P03-087 – 65<sup>th</sup> Street Village Center

- REQUEST:
- A. Environmental Determination: Negative Declaration;
  - B. Mitigation Monitoring Plan;
  - C. Special Permit to occupy more than 50 percent of the gross square footage on a residential development with non-residential uses in the 65th Street Transit/ University Village Area on 2.37± acres in the Residential Mixed Use Transit Overlay (RMX-TO) zone;
  - D. Special Permit to increase the amount of parking allowed for non-residential uses in the 65th Street Transit/ University Village Area on 2.37± acres in the Residential Mixed Use Transit Overlay (RMX-TO) zone (Withdrawn by Applicant);
  - E. Variance to increase the number of signs and sign area in a residential zone; and
  - F. Plan Review for the construction of a 42,550 square foot mixed use project within the 65th Street Transit/ University Village Area.

LOCATION: SW corner of 65<sup>th</sup> Street & Folsom Boulevard  
APN: 008-0010-003  
Sacramento Unified School District  
Council District 3

Exhibit 1F  
Elevations – Building B

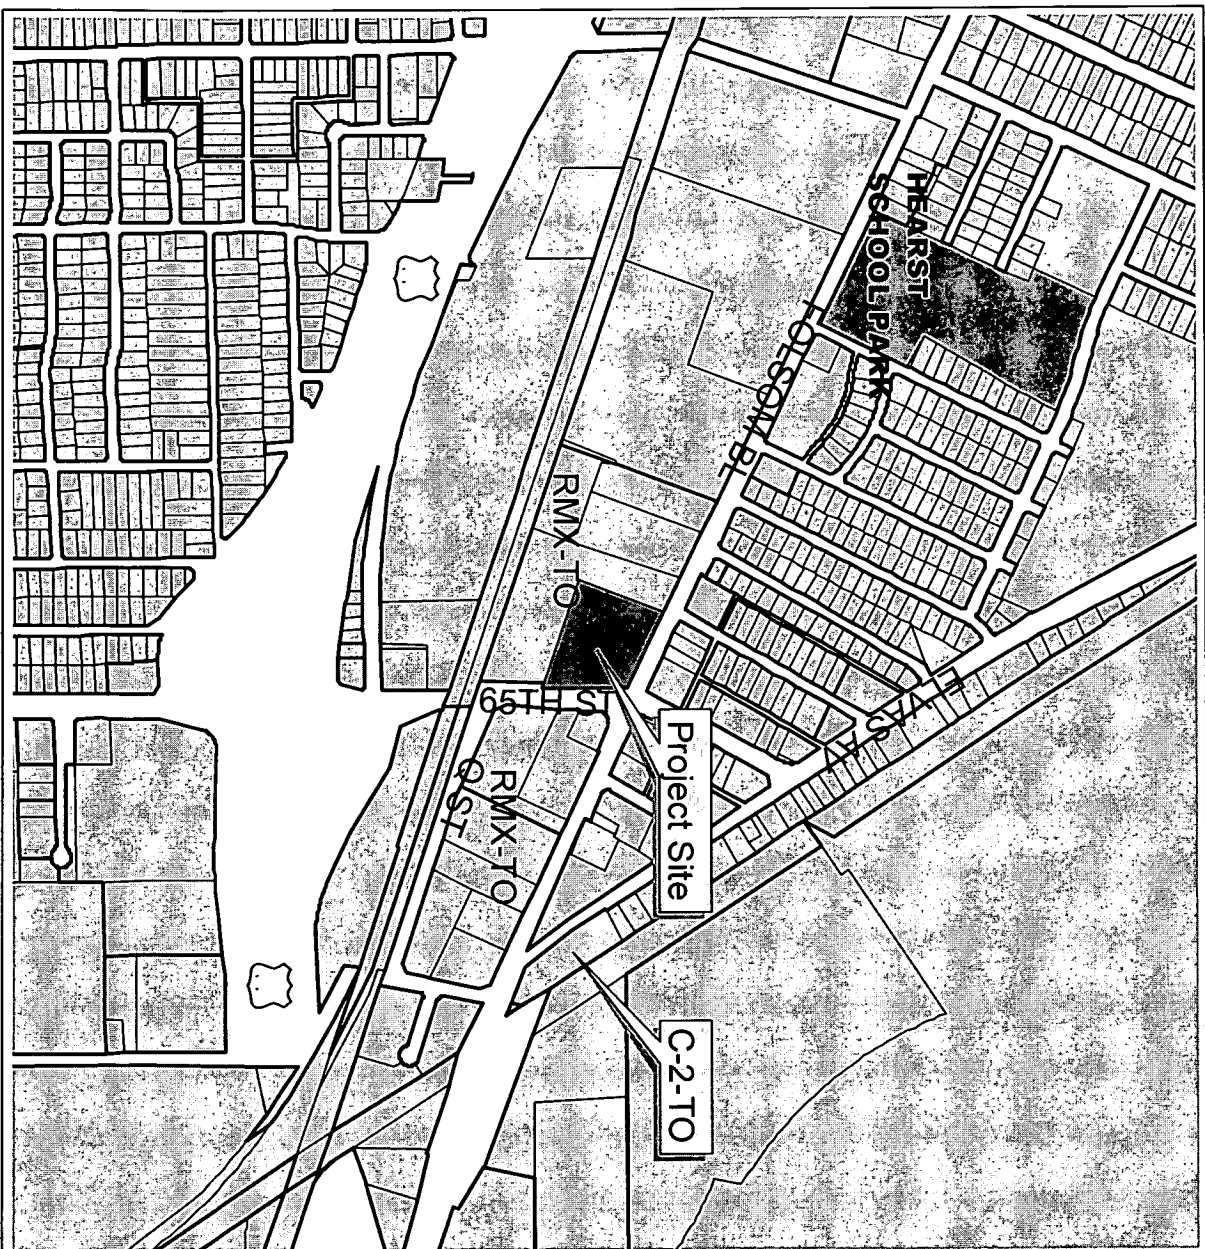
The applicant also proposes an attached identification sign for the shopping center on Building B, near the intersection of 65<sup>th</sup> Street and Folsom Boulevard. The sign area for this sign is over and above the attached sign area, as detailed above. Staff supports the provision of the "F-65" for the project, since the project is a 'catalyst' project for the area, providing an icon or focal point to the area. The "F-65" sign also can be considered as an architectural feature, enhancing the design and materials of the project. Staff has conditioned the sign copy for the attached "F-65" Center Identification sign to be no greater than 67 square feet in area, as shown on Exhibit 1F.

In lieu of providing a second monument sign, a freestanding "F-65" Center Identification sign integrated so as to be an architectural feature of the project, but considered as a sign by the sign ordinance, is proposed. This sign will complement the attached "F-65" sign, as stated above. As a catalyst project, staff agrees that these signs are appropriate to provide distinctive advertising for the shopping center that is unique, creating a lively, exciting, fun atmosphere, and adding architectural interest to the stairway and corner of the Building A. Staff has conditioned the freestanding "F-65" Center Identification sign be no higher than 55 feet in height, and 123 square feet in area, as shown in Exhibit 1F.
